Please adapt the polarity indication for the squawker and the tweeter in the drawings of the Service Manual.

Fig. 1

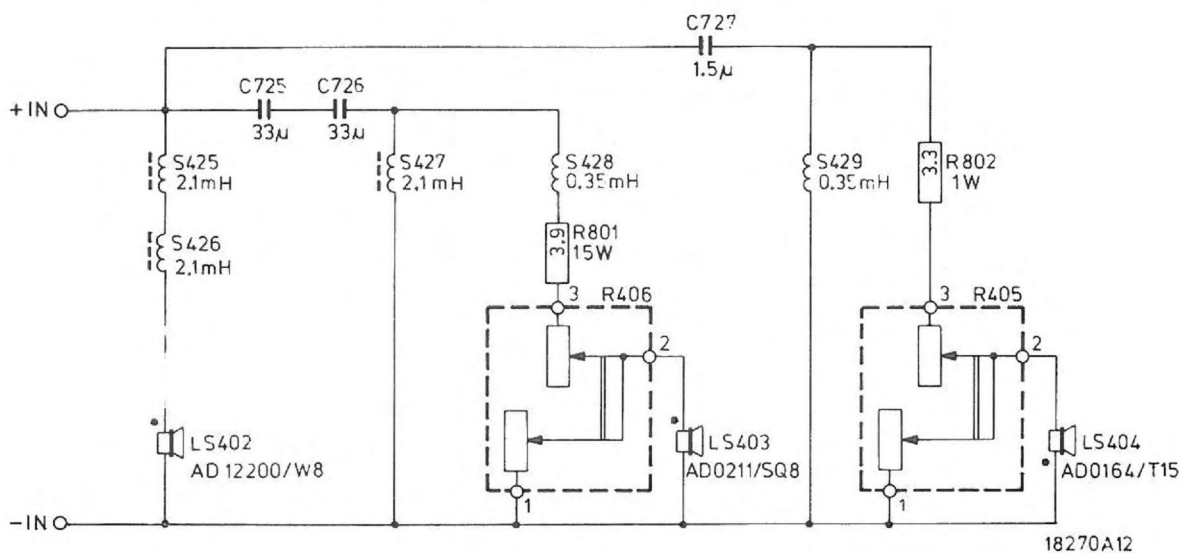
See Figures 1 and 2.
